ESQUIRE HOMES

PROJECT/LOCATION
NORTHGLEN PHASE 2
CLARINGTON, ONTARIO

SITE GRADING PLAN

LOT NUMBER 154

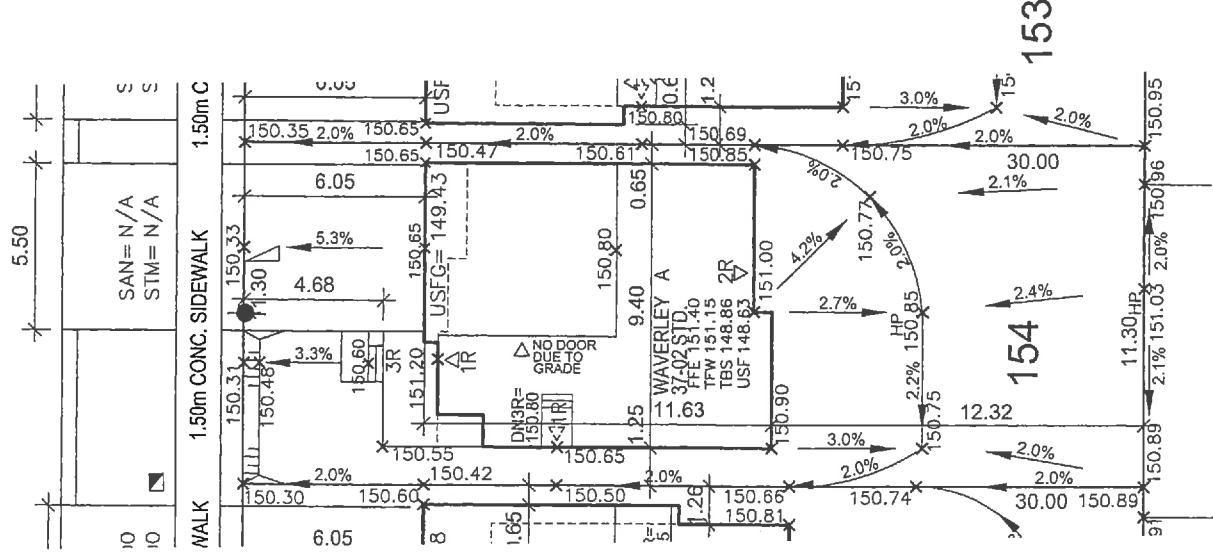
LOT NO. 154..... REGISTERED PLAN
THE PROPOSED LOT GRADING AND DRAINAGE IS APPROVED
AS BEING IN CONFORMITY WITH THE OVERALL APPROVED
GRADING PLANS FOR THE SUBDIVISION.

NO COMMENT ☒ REVIEWED BY GA
COMMENTS AS NOTED ☐ DATE Dec 7, 2015

THIS PROPOSAL CONFORMS WITH THE MUNICIPALITY'S GRADING CRITERIA AND APPROVED SUBDIVISION MASTER LOT GRADING PLAN AND THE PROPOSED HOUSE TYPE IS COMPATIBLE WITH THE GRADING. THE PROPOSED DRIVEWAY LOCATION DOES NOT CONFLICT WITH ADJACENT DRIVEWAYS, WALKWAYS, CATCHBASIN, HYDRANT, VALVE OR ANY STREET UTILITY.
